Bombay Commercial Vehicle Safety Centre – Response to Section 92 RMA Request for Further Information

To	Michele Schitko-Saboonchi; Vanessa Leddra
Copy	Belinda Petersen; Graham Taylor; Nitin Sahare; Fariz Rahman; Alisdair Simpson
From	Tina Kalmar
Office	Auckland
Date	26 January 2024
File/Ref	5C4353-WRP-04-MM-PL-1001
Subject	BUN60424934 – Notice of Requirement and regional resource consents for the Bombay CVSC – Responses to the s92 request from Auckland Council

BUN60424934 – Notice of Requirement and resource consents for the Bombay Commercial Vehicle Safety Centre – S92 Responses to Auckland Council

Figure 1 Key Performance Indicators

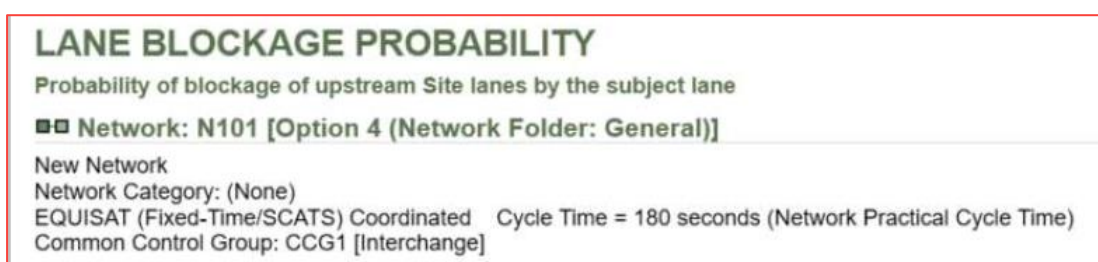
RFI 17. Traffic Modelling. Provide evidence to demonstrate that 3 minutes is an appropriate measure for the maximum time for motorists to wait before entering the intersection.

Key performance indicators for evaluating the intersection's performance encompass the Level of Service (LOS), Degree of Saturation (DoS) and Average Delay. In the modelling analysis, refer to Figure 1 below, the cycle time of 180 seconds was set up in the signalised intersection models as a network practical cycle time. The mentioned 3 minutes in the report serves as an illustrative example of network cycle time rather than a decisive trigger indicator.

Figure 2 – CVSC Site manoeuvres

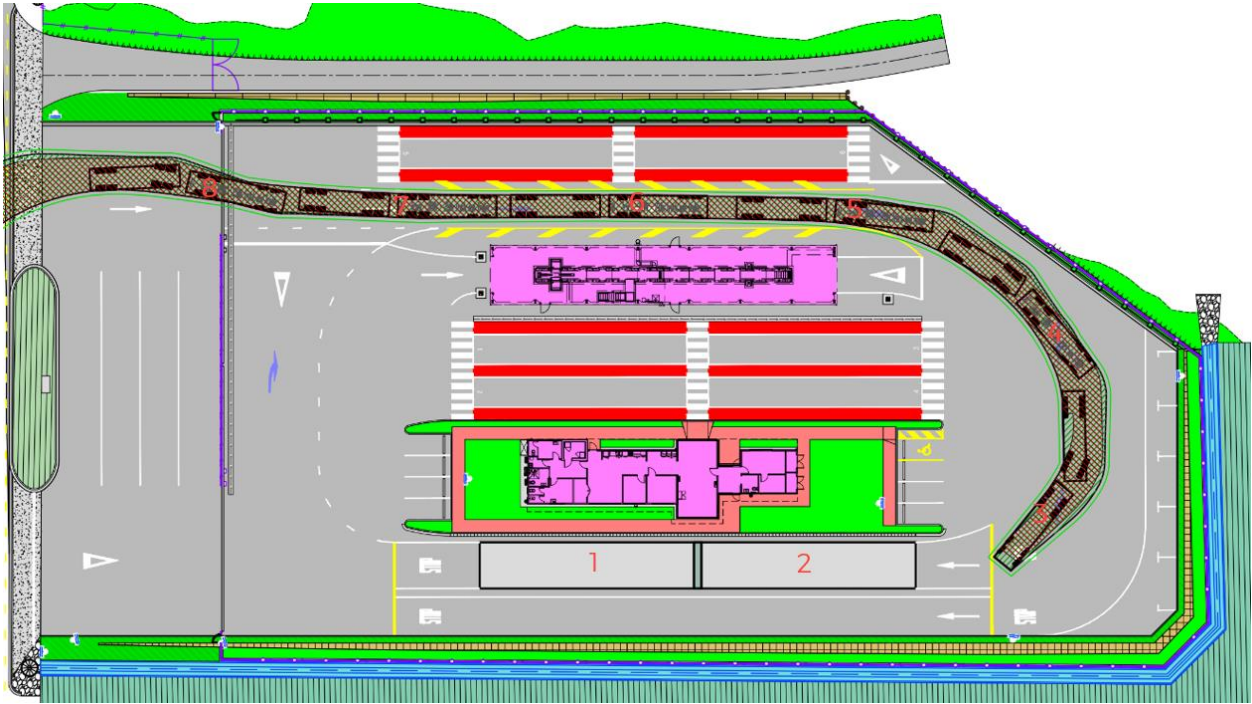
RFI 29. Site Operation. Provide details of how oversized vehicles will be managed when there are already trucks in the inspection bays to prevent trucks from queuing back into the adjacent road reserve.

The initial step in the truck inspection process involves proceeding to the weigh bridge and subsequently navigating to various bays under the guidance of staff. As illustrated in Figure 2 below, the CVSC has capacity to simultaneously accommodate a maximum of eight trucks with trailers, each extending up to 23 meters in length, including two vehicles on the weigh bridge. As outlined in RFI 12 regarding trip generation, during the peak hour, a maximum of 17 vehicles will visit the CVSC at different intervals, a capacity that can be effectively managed on-site.

The oversized vehicles will also be required to operate with a permit. Therefore, the police and NZTA will know about these oversized vehicles in advance. It is unlikely that a vehicle of that size (10m wide) will be on the road during atypical hours of operation for this site because they usually drive overnight.

Regarding the inspection bays, the bays at the top of the site are likely to be used last. They are there for peak times but will not likely be used as the primary option because they require a circular manoeuvre around the site to enter. It is highly unlikely that a vehicle 10m wide would be on the site at the same time these inspection bays are in use. If this were to happen then the vehicles in the northern inspection bays would have to move to the offload area and allow the oversized vehicle to manoeuvre through the site (and potentially occupy more than one inspection bay). The drivers will be with their trucks during the inspection process and thus will be able to move their trucks quickly upon request.

Figure 3 - Typical cross-section of the timber retaining wall showing proximity to the delineated wetland extent (refer to Drawing Sheet C-3010)

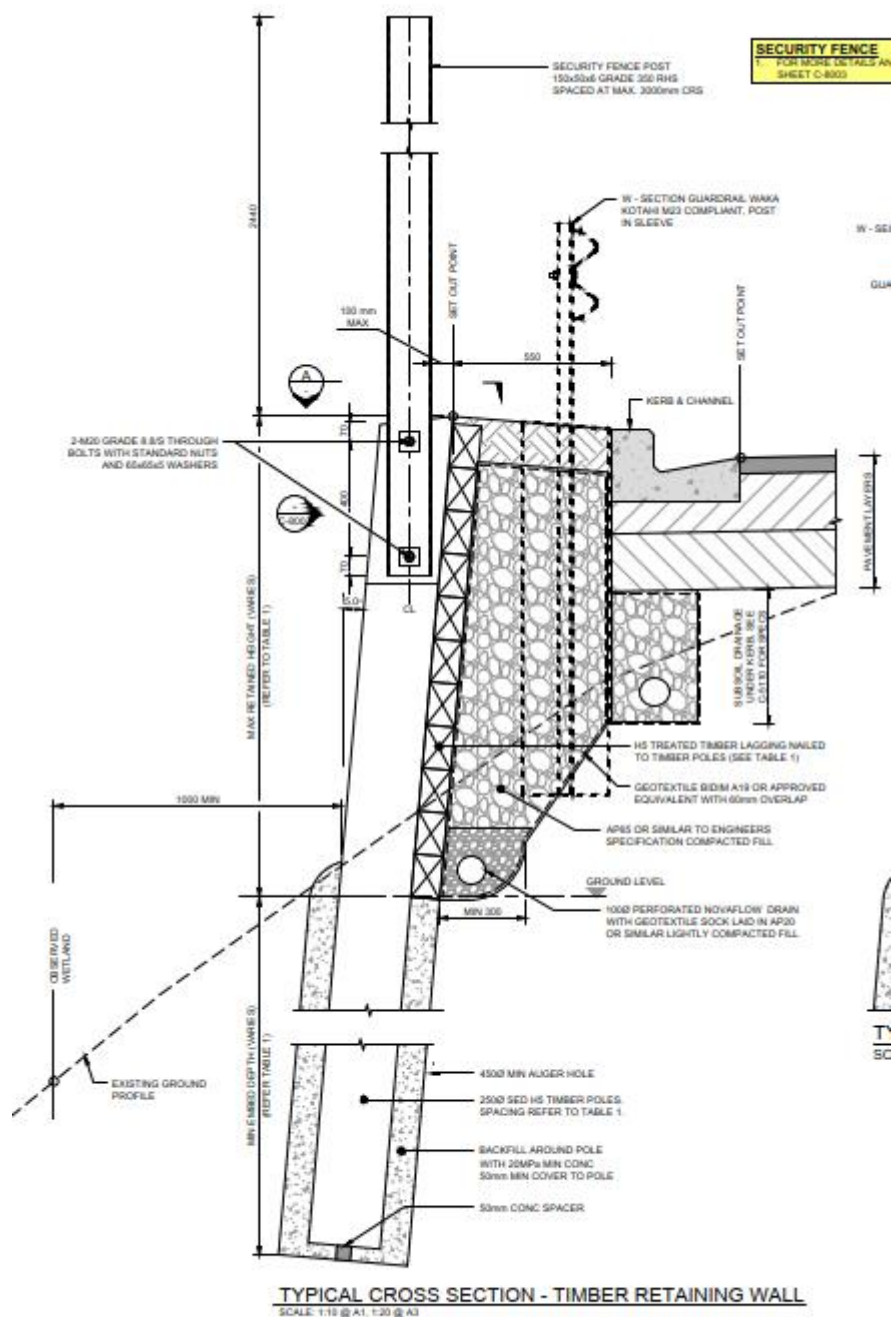
RFI 62. The AEE indicates that consent is required for E3.4.1 (A44) Any activities not complying with the general permitted activity standards in E3.6.1.1 or the specific activity standards in E3.6.1.14 to E3.6.1.23. Please discuss what activities trigger the need for this consent and clearly indicate the location of this activity on a plan.

Temporary diversion and damming of surface water may be necessary in proximity to the wetland area during construction. The proposed methodology could entail sheet piling during earthworks with necessary rigorous erosion and sediment controls as per the final Erosion and Sediment Control Plan. This will protect the temporary cut slope on the north-eastern boundaries adjoining the wetland until building the permanent retaining walls. As shown in Figure 3 (C-3010) provided in **Appendix 18**, the proposed construction method will be implemented within a restricted space of approximately 900mm between the wetland perimeter and the base of the permanent retaining wall.

In the absence of detailed construction methodology, it is anticipated there will be temporary structures (E3.6.1.15) at the interface between the retaining wall and the wetland on the north-east corner of the site. Under E3.6.1.15 the temporary structure must not be in place longer than 14 days within any 6mth period.
